ISH 2 Hearing Action Points

London Pilots Council (LPC) Submission

15th January 2019

Fig.1. Requested reduction of the Red Line Boundary

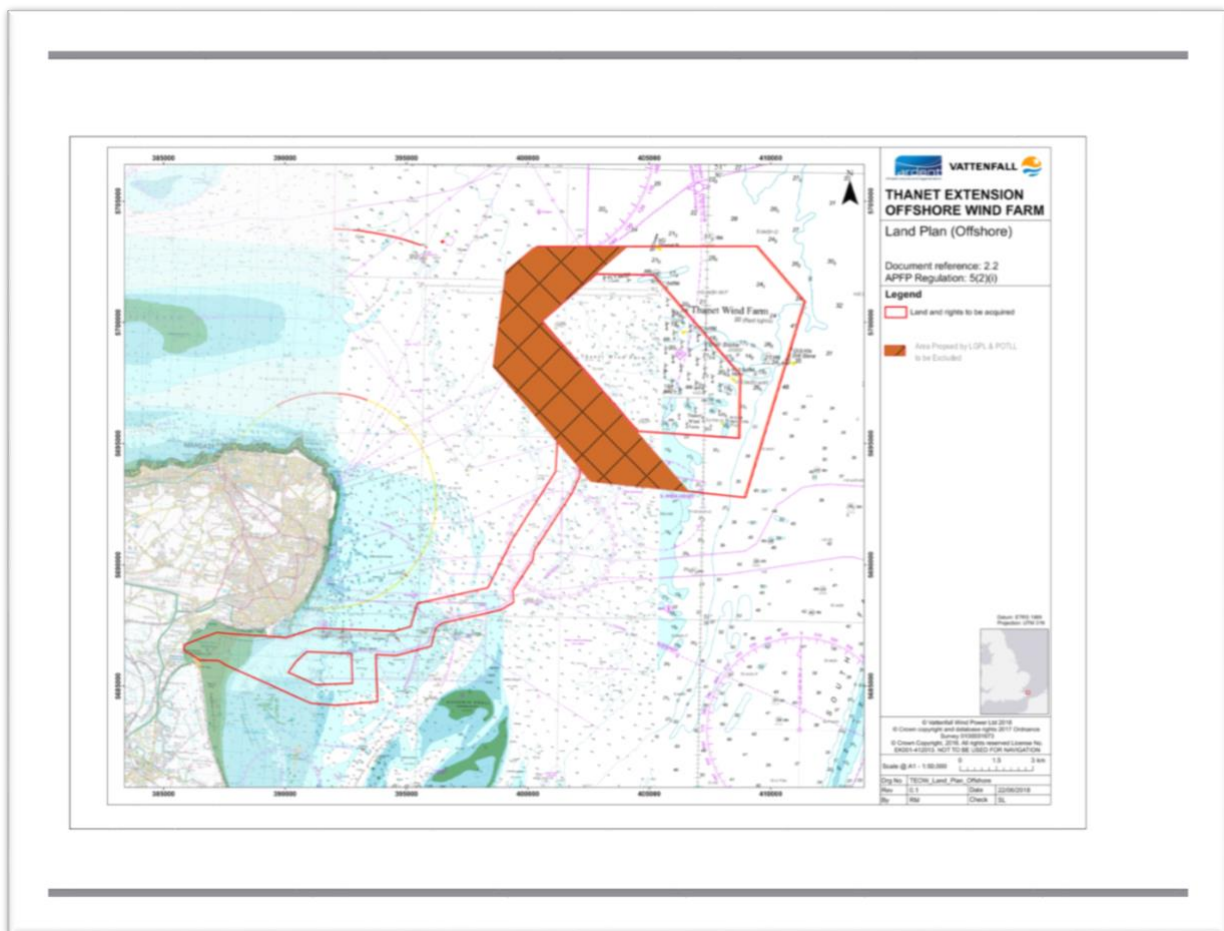
- i The LPC considers the proposed extension to the Thanet Windfarm to have considerable impact on the Safety of Navigation of vessels transiting the NESP sea area due to greatly reduced sea room caused by the proposed Windfarm extension and in particular having a significant Pilot safety and Pilot logistics impact on Pilot boarding and landing operations at the NESP Pilot station.

- ii The LPC considers that in its collective professional opinion the risk of collision, grounding and near miss for Large and Medium sized vessels is greatly increased due to the restricted vessel manoeuvring areas and narrow corridors for transiting the area that the extension together with the 0.5Nm exclusion zone, will create.

vi Fig. 1. The LPC requests that the Western boundary of the planned extension is removed as shown by the hatched/ shaded area shown in Fig.1

Fig.3. Available sea room following the proposed Thanet Windfarm Extension

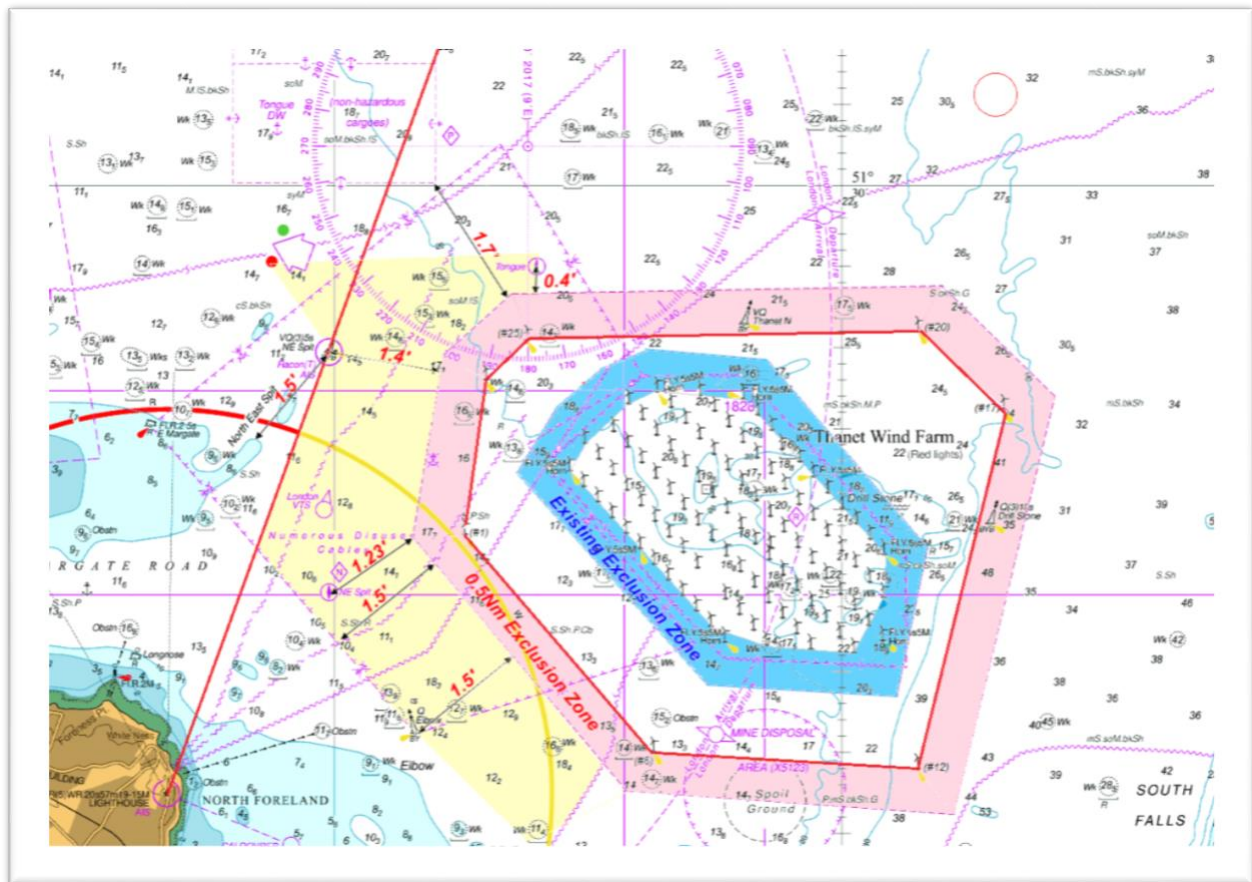
The Netherlands assessment of sea room requirements based upon PIANC assessment for channel design suggests a buffer free zone of 2 nautical miles between wind farms and shipping lanes. Fig. 3 Shows the available sea room available following the proposed Windfarm extension .

10.3.iii. The Thanet Windfarm Extension clearly falls below that recommendation as the sea lane to the North of the extension and the Tongue anchorage, a main seaway or thoroughfare used to serve the Princes Channel, has available sea room of 1.7 miles, reduced from 3.0 miles. This is a loss of 43% of available sea room and well below the guidelines of 2 miles found in MGN 453.

10.3.v. If 4 x 400m vessels pass, maintaining 2 x 400m distance apart, each vessel having a beam of 50m and passing one ships length from the extremities of the channel then the MGN 543 guidelines are again not met for the main seaway to the North of the extension.

$(3 \times 800) + (4 \times 50 \text{ beam}) + (2 \times 400 \text{ extremities}) = 3,400\text{m} / 1852. = 1.83\text{miles}$
The available sea room to the North of the Windfarm between the exclusion zone and the Tongue anchorage is only 1.7 miles, clearly less than that advised in MGN 543 Annex 3 10.a.iv and v.

Fig. 4. Rerouting large and medium sized vessels

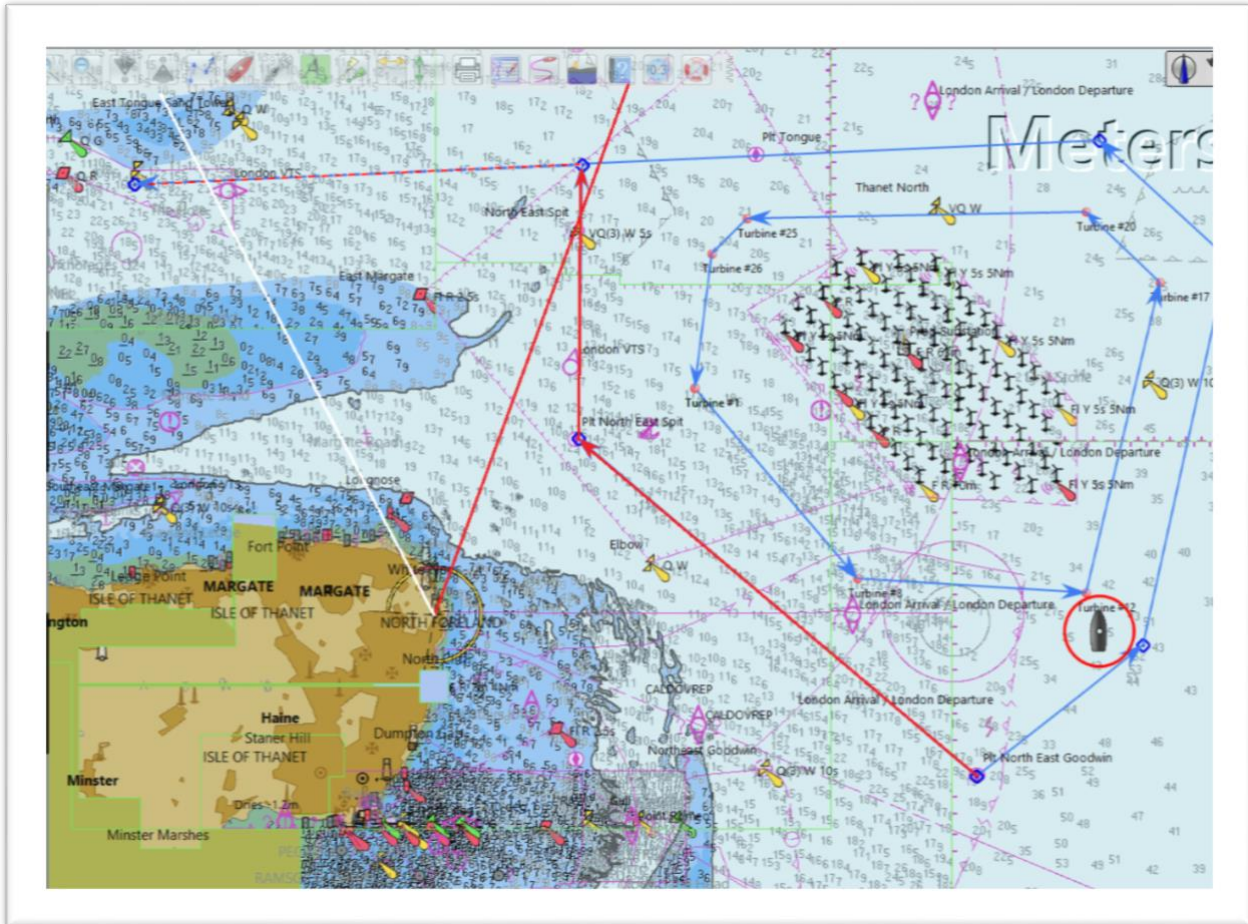
13.4. Large and medium sized vessels may be routed to the East and North of the proposed Windfarm. This would necessitate boarding Pilots at the NE Goodwin and transiting around the extended Windfarm maintaining a 0.5mile exclusion zone. The total distance from the NE Goodwin to the Princes Outer Buoy at the start of the

13.5. Princes Channel is 25.4 N miles. This is an increase of 7.8 miles or 45 to 50 minutes per vessel transit.

- **NE Goodwin inbound via NESP Pilot boarding diamond 17.6 mls**
- **NE Goodwin inbound passing around Windfarm extension 25.4 mls**
- **Additional passage distance 7.8 miles / 50 mins**
